RE: BZA #20382, Joint Parties in Opposition Motion to Strike Certain Drawings Submitted by Applicant

Re: **CAS Job No. 21-256-DC**
308 11th Street, SE
Lot 0068, Square 0963
BZA Case 20382
Site Observations/Analysis

Annotated Portion of Exhibit 2

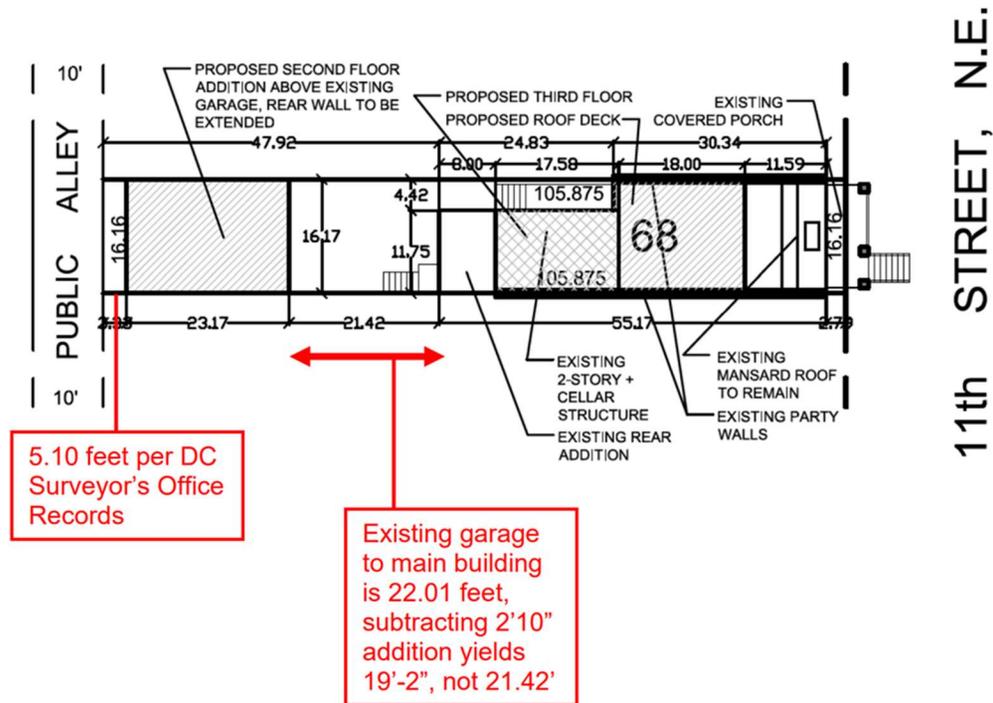
- Plat shows 21.42 ft. between the garage and rear wall of the existing house with the 2 ft. 10 in. extension. The actual existing distance without the 2 ft. 10 in. extension measures to 22.01 ft. on-site. After extending into the rear yard an additional 2 ft. 10 in., this dimension would be significantly less than the 21.42 ft. shown with an extension to the garage rear wall, approximately 19 ft. 2 in. See letter from David C. Landsman, April 12, 2021.
- Plat shows the garage building 3.33 ft. from the rear property line. DC Surveyor's Office Records show the garage building set back 5.1-ft., which was confirmed by field measurement (5.05 ft.) by David Landsman. See letter from David C. Landsman, April 12, 2021.

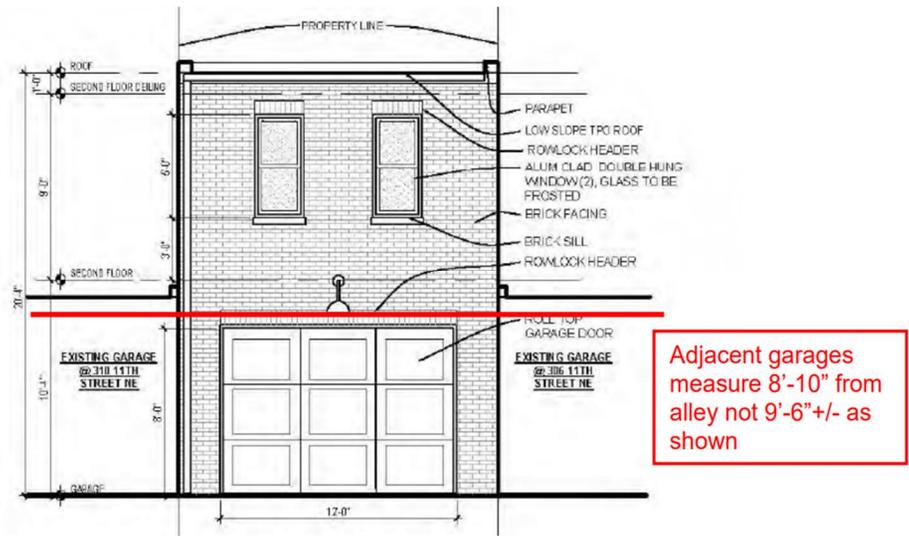
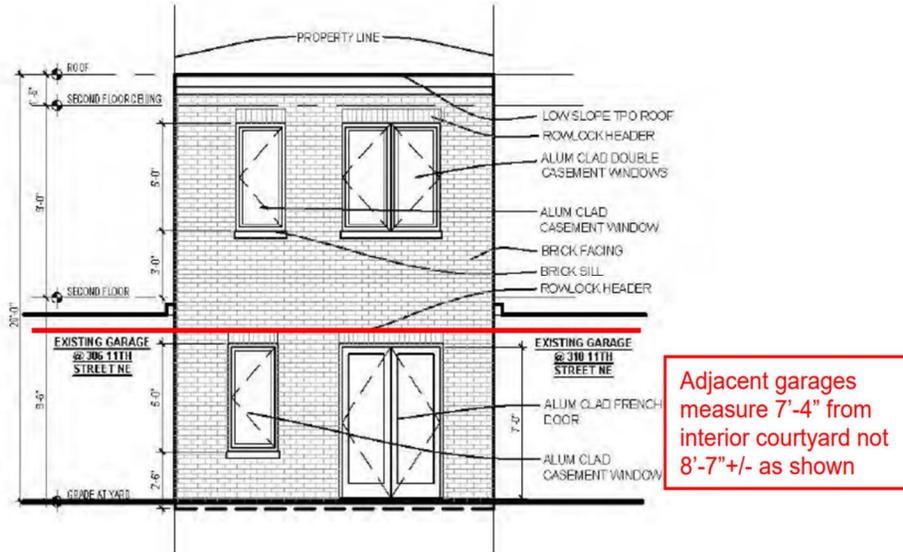
- Pg. 11, A-3, shows inaccurate heights of adjacent garages. Field measurements of yard elevation show height of adjacent garages is 7 ft. 4 in., not 8 ft. 7 in. Field measurements of alley elevation of existing garage is 8 ft. 11 in., not 9 ft. 6 in. These significant errors call into question the accuracy of the Applicant's assessment of privacy, light (shade study), and air impacts. (Annotated Portion of Exhibits 51A. Pg. 11 (A-3), applies to Exhibit 6.) See letter from David C. Landsman, April 12, 2021.

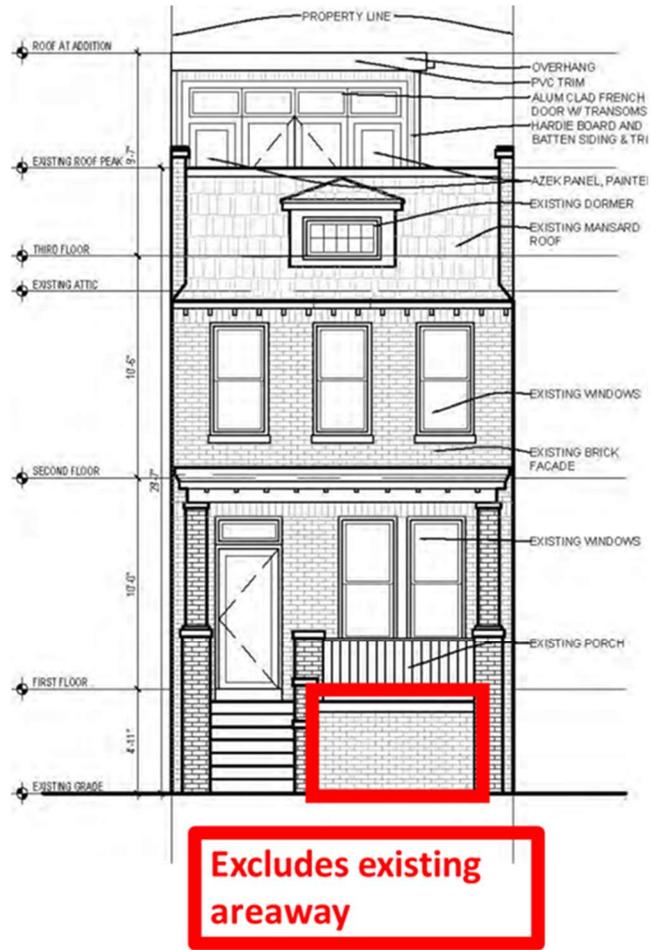
- Pg. 12, A-4, shows an inaccurate main house front elevation that excludes the existing areaway into the basement apartment, which could indicate the proposed 2-level garage carriage house may potentially be intended as the 2nd flat of the 2-family flat, rather than as an office space for the main building, which would increase the privacy implications to the adjacent neighbors. (Annotated Portion of Exhibits 6 & 51A. Pgs. 12 (A-4).)

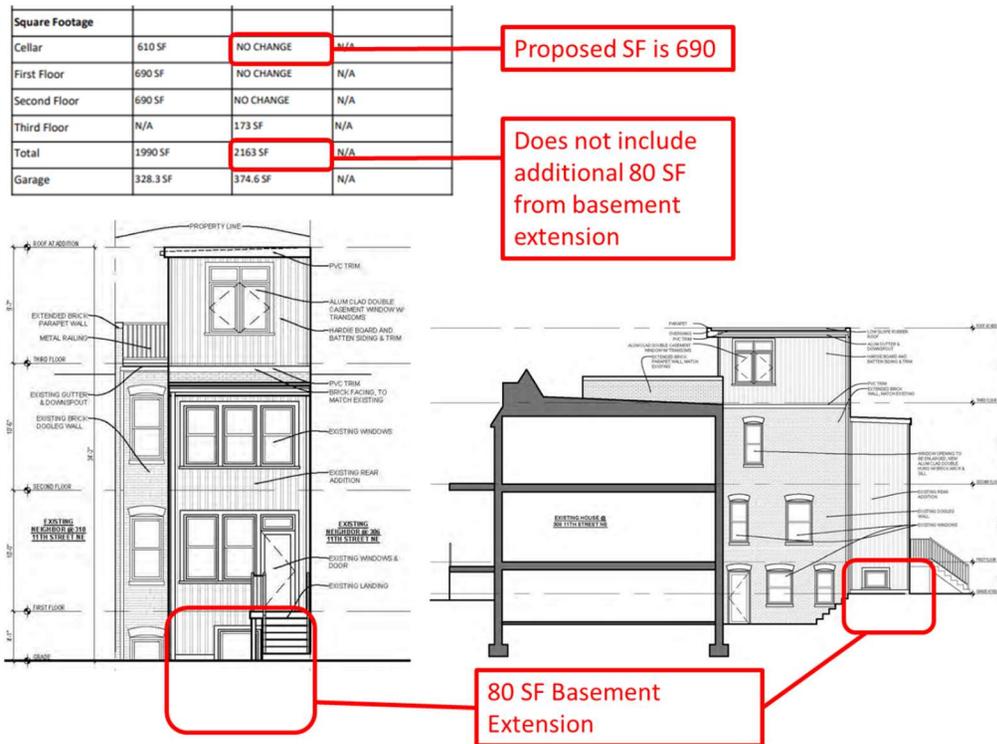
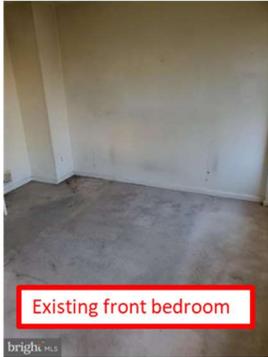
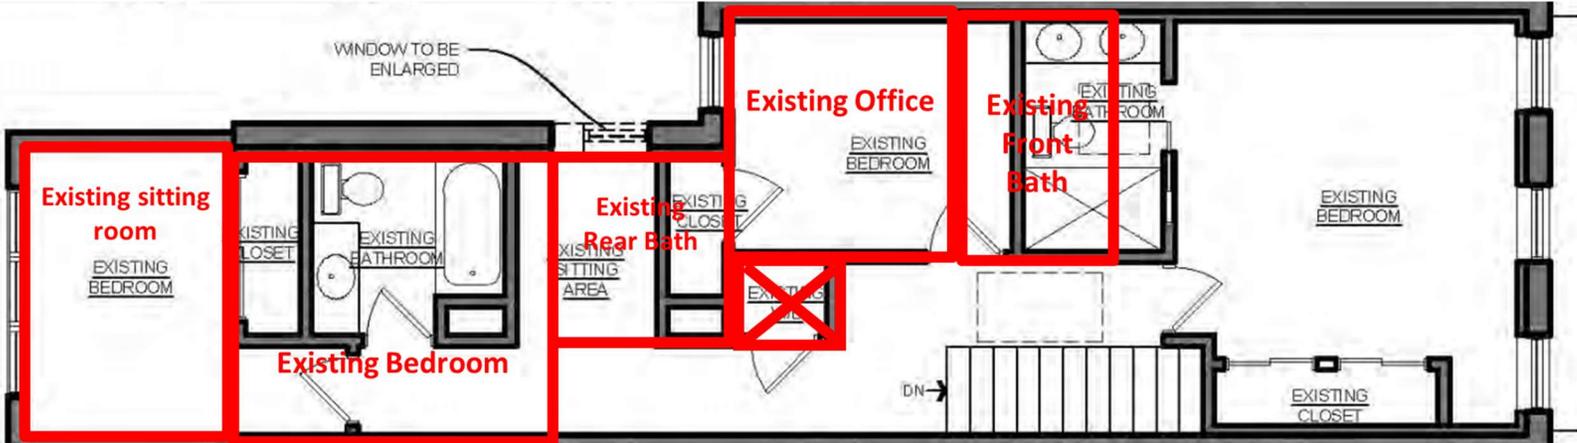
- Pg. 1. The “no change” to the proposed cellar sq. ft. is not consistent with the 690 sq. ft. in the existing/demo and proposed floorplan drawings submitted April 30, 2020 for Applicant’s building permit B2007169. This “no change” in basement SF is also not consistent with the Applicant’s drawings on pgs. 12 & 13 of the same Exhibits showing a 3-level rear addition with basement, labeled inaccurately as “existing.” On pg. 1, the proposed total SF is also inaccurate because it does not reflect the additional 80 SF from the basement extension that is included in the proposed 3-level rear addition. (Annotated portions of Exhibits 6 & 51A, pgs. 1, 12, 13.)

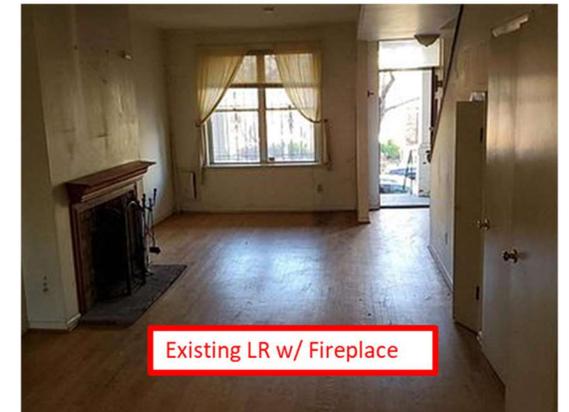
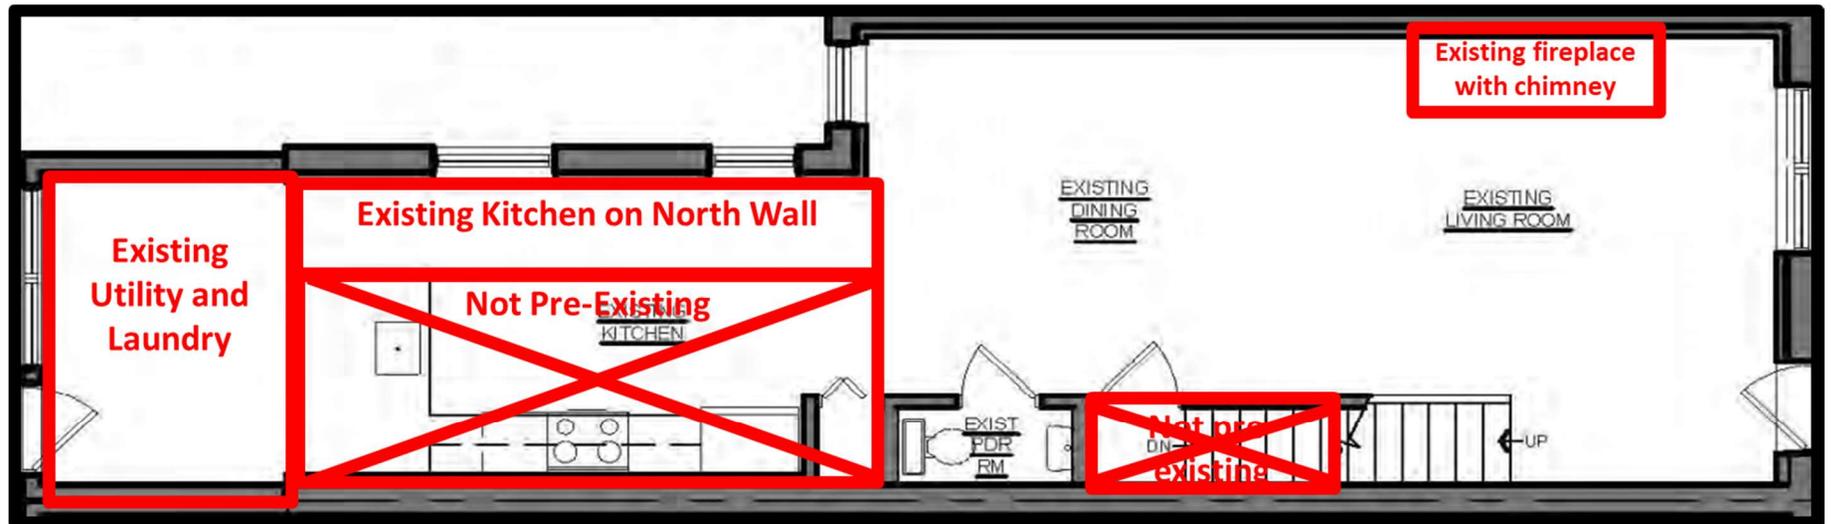
- Pg. 8, D-1, shows inaccurate “existing” layout of second floor. This drawing does not represent the actual second floor layout in April 2020 when the same inaccurate layout was used to obtain building permit B2007169. Overlays on Applicant’s drawing show layout. MLS photos illustrate layout. (NOTE: overlays NTS but are best efforts.) (Annotated portion of Exhibits 6 & 51A pg. 8 (D-1).)

EXISTING REAR FACADE

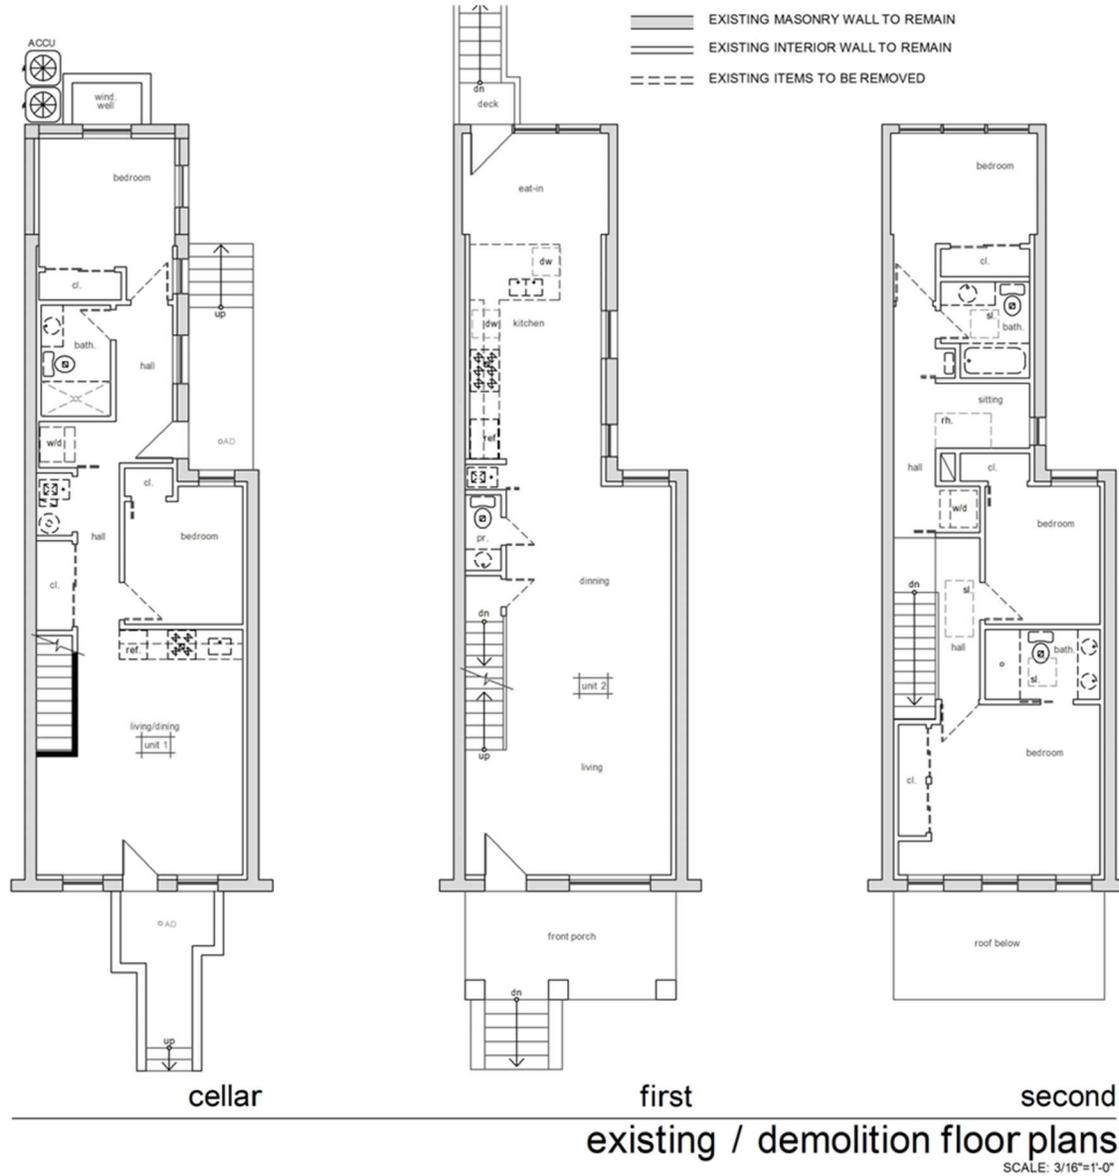
- Pg. 12, A-4 and pg. 13, A-5, show an inaccurate rear elevation of a 3-level rear addition with basement extension, rear basement windows, and a window well extending into the rear yard, which are labeled as “existing.” These drawings do not reflect prior or existing conditions. These drawings correspond to the inaccurate basement layout that was used to obtain building permit B2007169. These drawings conflict with the drawings of the side elevations on pgs. 6 (C-6), 7 (C-7), and 14 (A-6) of the same Exhibits, which show a crawl space under the existing 2-level rear addition but which are labeled as “existing.” (Annotated Portion of Exhibits 6 & 51A Pgs. 12 (A-4) & 13 (A-5).)

Annotated Portion of Exhibit 2

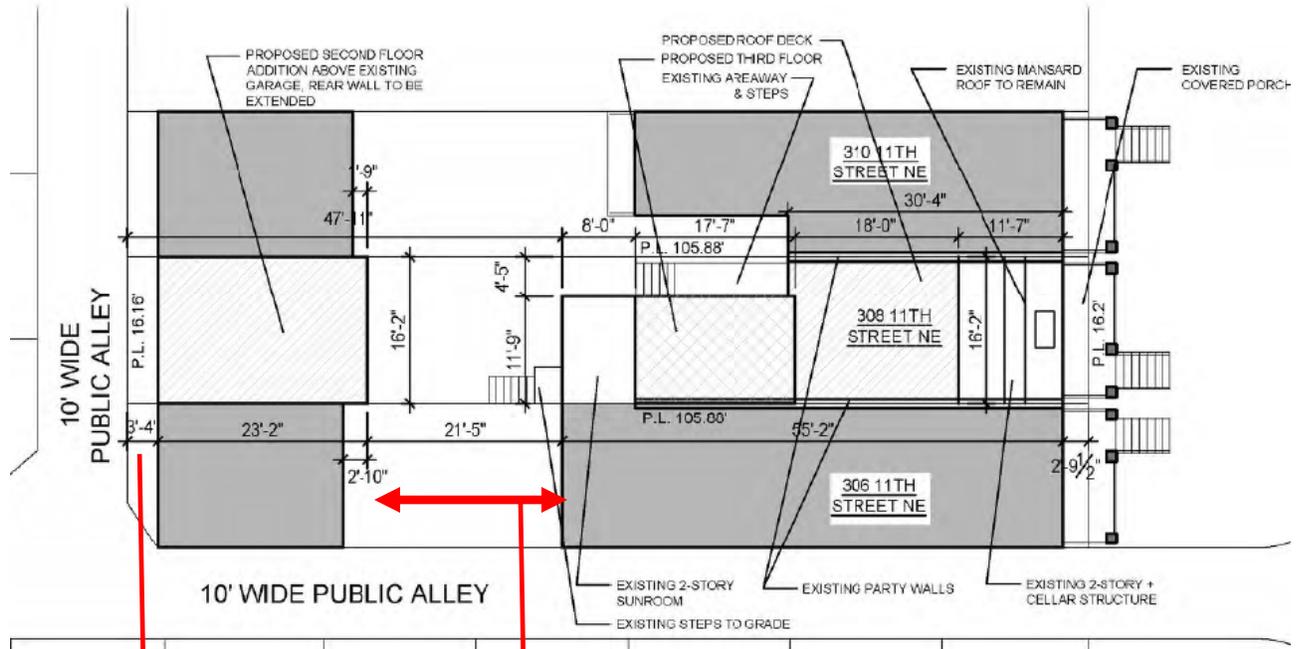
5.10 feet per DC Surveyor's Office Records

Existing garage to main building is 22.01 feet, subtracting 2'10" addition yields 19'-2", not 21.42'

Annotated Portion of Exhibits 6 & 51A

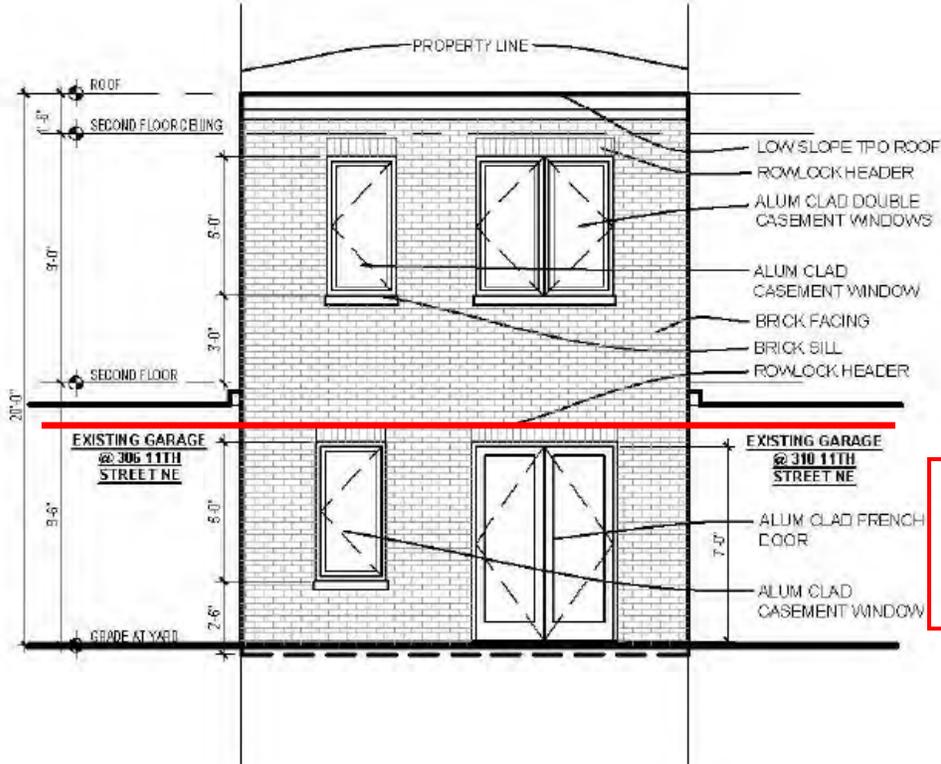
5.10 feet per DC Surveyor's Office Records

Existing garage to main building is 22.01 feet, subtracting 2'10" addition yields 19'-2", not 21.42'

Annotated Portion of Exhibits 6 and 51A

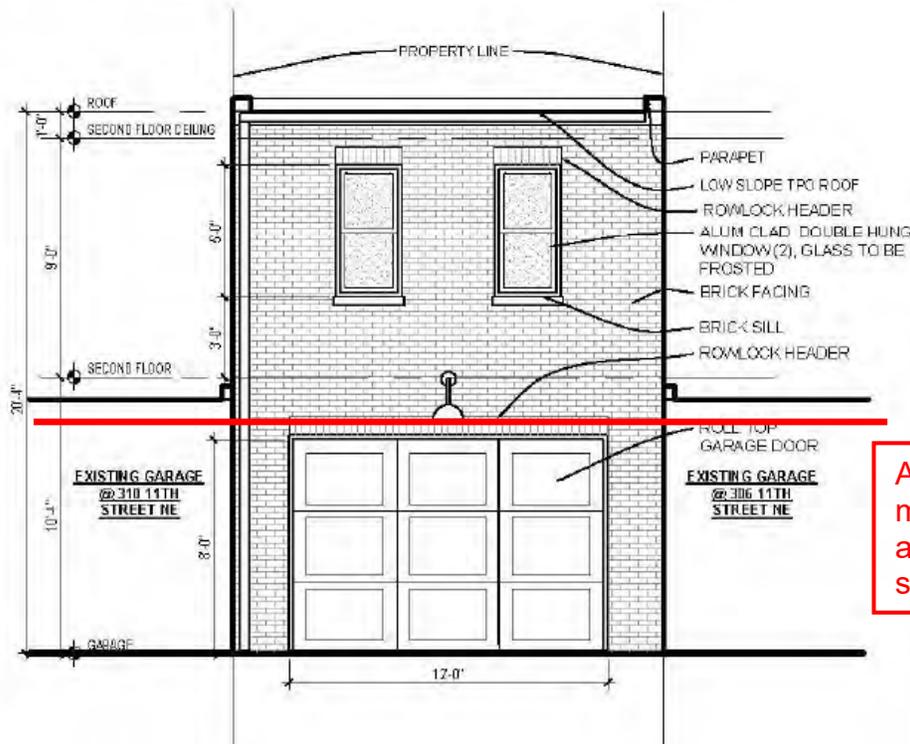
Adjacent garages measure 7'-4" from interior courtyard not 8'-7" +/- as shown

Adjacent garages measure 8'-10" from alley not 9'-6" +/- as shown
